IEEE P1394.1 reflector thread regarding multiple paths

Editor's note: This email thread discusses the issues of whether a response should be routed back through the reverse of the path taken by the corresponding request, and whether multiple paths should be allowed between two buses. The emails were posted to the IEEE P1304.1 reflector between 6/25/98 and 7/12/98.

Dick Scheel
Chair, IEEE P1394.1
8/4/98

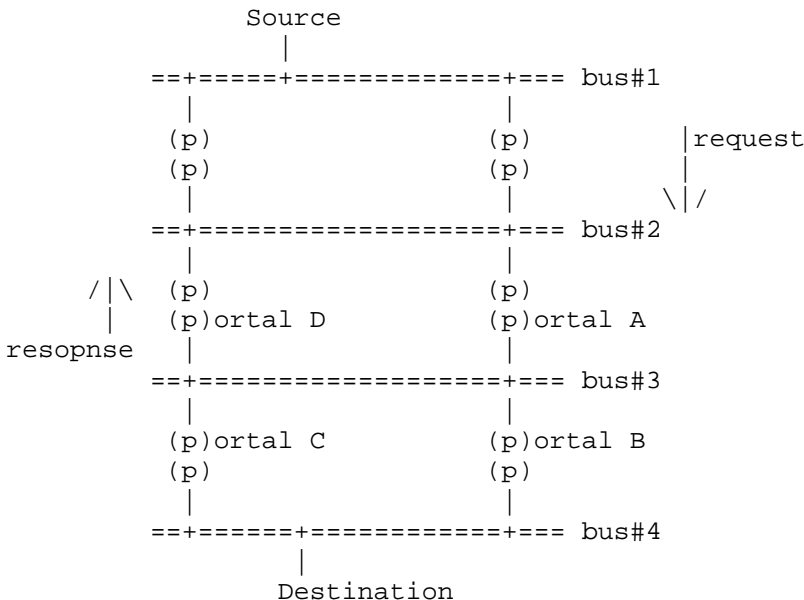
Suppose the net has 6 buses with six bridges which is drawn as the figure bellow;

The source is on the bus#1 and the destination node on the bus#6.
A request packet from the source might be coming to the destination through the right side path, but its response keeps the track of the left side path.

In this case, the portal A in the figure should forward the request to the portal B on the bus #3, and I am sure it can get its ack_pending generated by the portal B. And the portal A shall be waiting for its response until waiting time is over, that is exactly what I was asking. Thank you for the answer, Domon-san.
Then the time is going to be over because the response is not coming to the portal A.

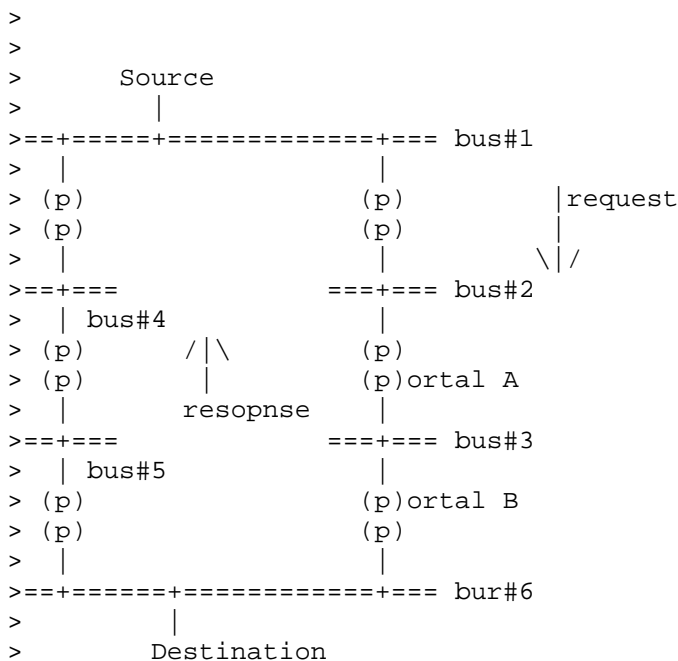
I was thinking item #2 using the following configuration (sorry, I prepared this figure by modifying your drawing).

In this figure, there are four bridge portals (A, B, C and D) on bus #3. Portal A and B are on the request path and portal C and D are on the response path. The most different point from your configuration is that portal A (it's waiting for a response packet) could detect the response packet transmitted by portal C. But another issue arises in this figure that two portals will send an ack packet after receiving the response packet from portal C. Portal D needs to receive the response packet for transferring the packet to bus #2, and portal A also needs to receive for doing split-transaction.

Another question occurred to me: Does portal B want to send a response packet after sending `ack_pending` to portal A? I think the answer is 'yes'.
